**EAST GOSHEN TOWNSHIP
PLANNING COMMISSION
Meeting Agenda
Wednesday, May 4, 2022
7:00 PM**

Re: Preliminary Land Development Plan
Malvern Institute - 940 King Road
CVE Project No. 21465-0000

August 16, 2021

Site Plan Detail, Sheet 1: Preliminary Land Development- Malvern Institute 2nd Story Building Addition

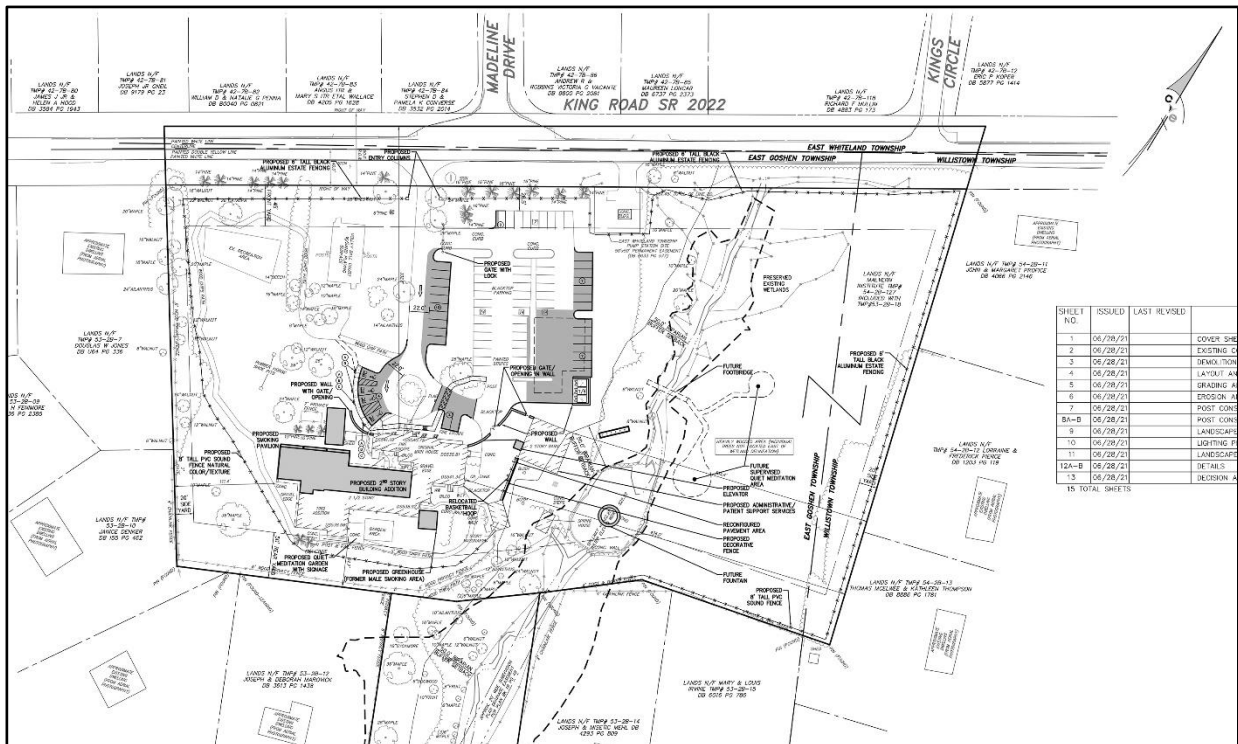
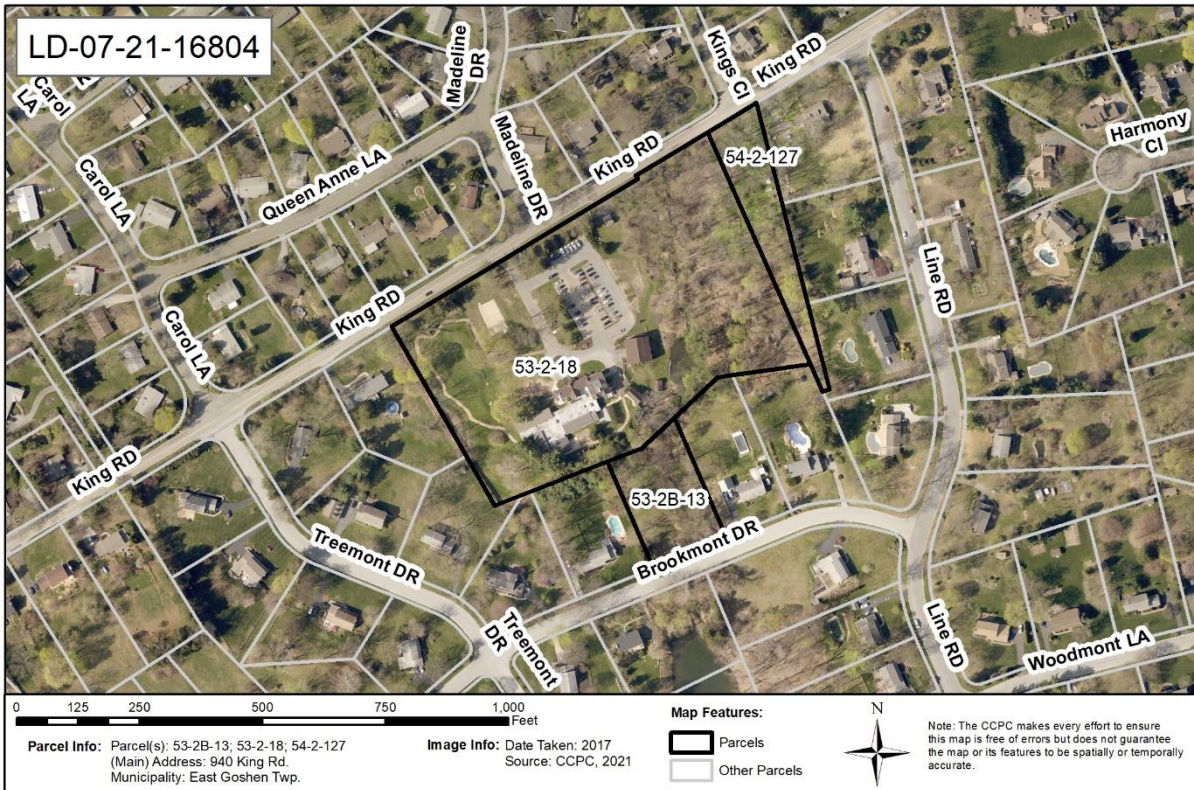
3. The Township should verify that the design of the proposed outdoor lighting plan (Sheet 10) conforms to Township ordinance requirements. The illumination should be directed inward from the periphery of the site and be oriented to reduce glare and visual impact on the adjoining roadways and land uses.

4. While we acknowledge that Sheet 9-Landscape Plan depicts that extensive landscaping will be provided along the northern, western, and southern parcel boundaries (west of the existing floodplain area), we recommend that the applicant and Township consider planting additional trees, shrubs, and ground cover in areas currently covered by lawn within and adjacent to the parking areas. [Landscapes3](#) recommends that developments in the **Suburban Landscape** include extensive landscaping in parking areas (page 39).

8. Sheet 13-Decision and Order Letter indicates that the Township Zoning Hearing Board granted approval for this project with 28 conditions of approval. We note that the conditions of approval include the following:
